MISSISSIPPI POWER & LIGHT COMPANY

SUBJECT: Grand Gulf Nuclear Station  
Units 1 and 2  
Docket Nos. 50-416 and 50-417  
File 0260/L-814.2  
SQRT - Additional Information  
Supporting Justification for  
Interim Operation; Response to  
NRC Questions at 4/21/82  
Meeting  
AECM-82/229

Attachment No. 3 provides the Response Spectra requested by EQB during the April 21, 1982, meeting. The enclosed Response Spectra are for the SSE, SRV, Pool Swell, and the LOCA Envelope for the Containment and Drywell in the area of the HCU floor.

- Attachments:
1. Grand Gulf SQRT Program Requalification Schedule
  2. Grand Gulf Power Ascension Schedule
  3. Response Spectra for SSE, SRV, Pool Swell, and  
LOCA Envelope
  4. Air Operated Butterfly Valves
  5. Main Steam Isolation Valves
  6. HPCS Diesel Generator System
  7. Conductivity Cell
  8. Miscellaneous Information

## III. Method of Analysis

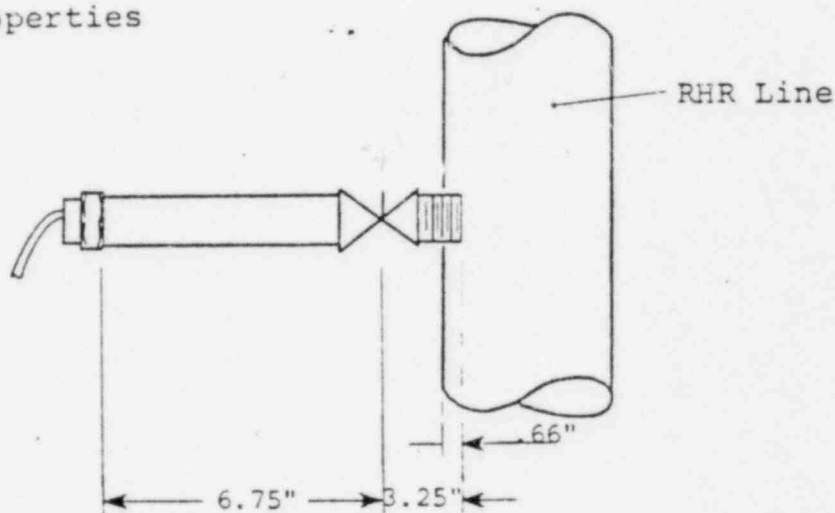
The questions of why the stress analysis did not consider the threads in the nipple will be addressed at the June 2, 1982, meeting.

The most critical component affecting the pressure integrity of the conductivity cell is the 1" nipple. (Which connects the 1" valve to the RHR line.) The stress in the 1" nipple is estimated according to dead weight, thermal expansion, and seismic loads.
